IEEE 802.16 Broadband Wireless Access Working Group <<http://ieee802.org/16>>

Title **Bi-directional PKM messages for EAP messages**

Re: Recirculation Ballot #14b Announcement

[Add/Change/Delete the following as shown to IEEE 802.16e/D3]

[Reference] Call flow

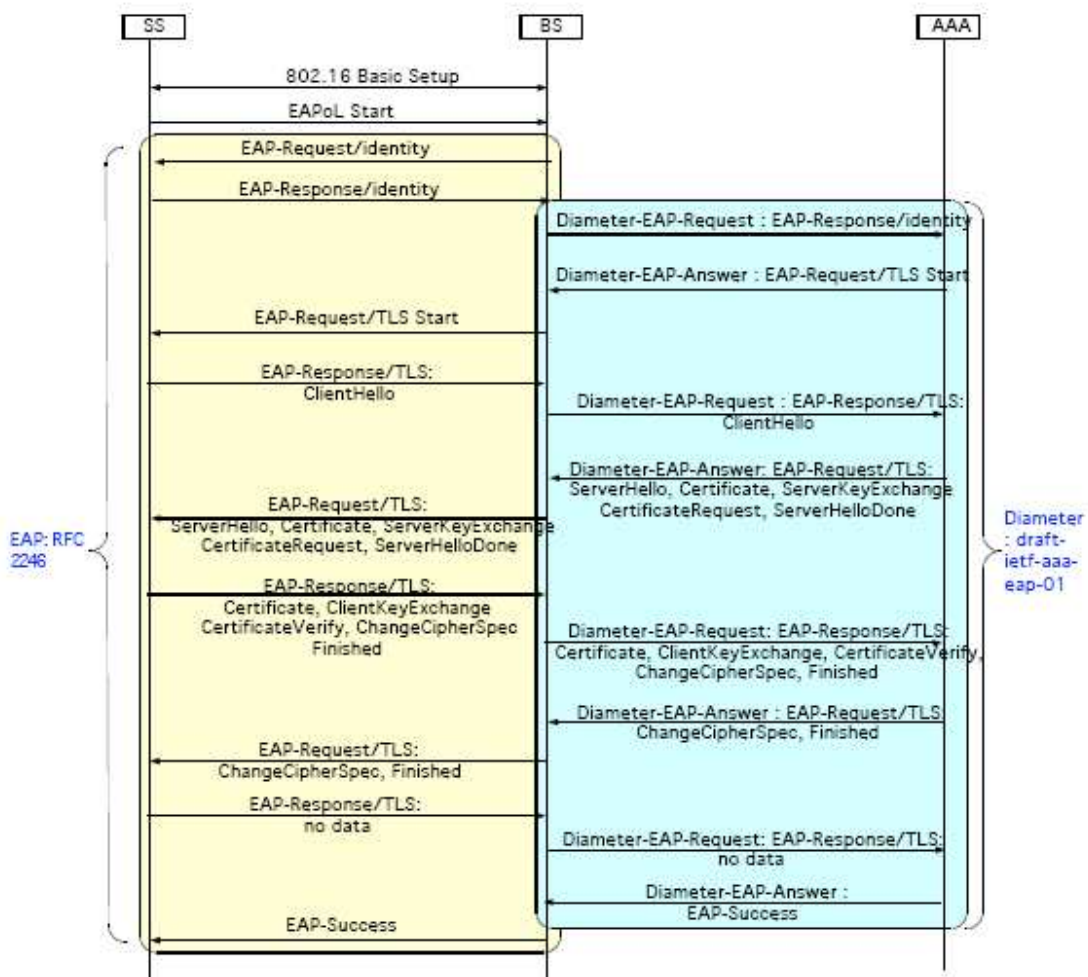
EAP Request message is sent from BS to MSS, however PKM Request message is sent from MSS to BS. So EAP Request message is not mapped to PKM Request message. In order to solve this problem, PKM messages should be changed to bi-directional. And considering the fact that MAC management layer is agnostic about EAP messages code, EAP-Transfer-Request and EAP-Transfer-Response messages shall be incorporated into one EAP-Transfer message.
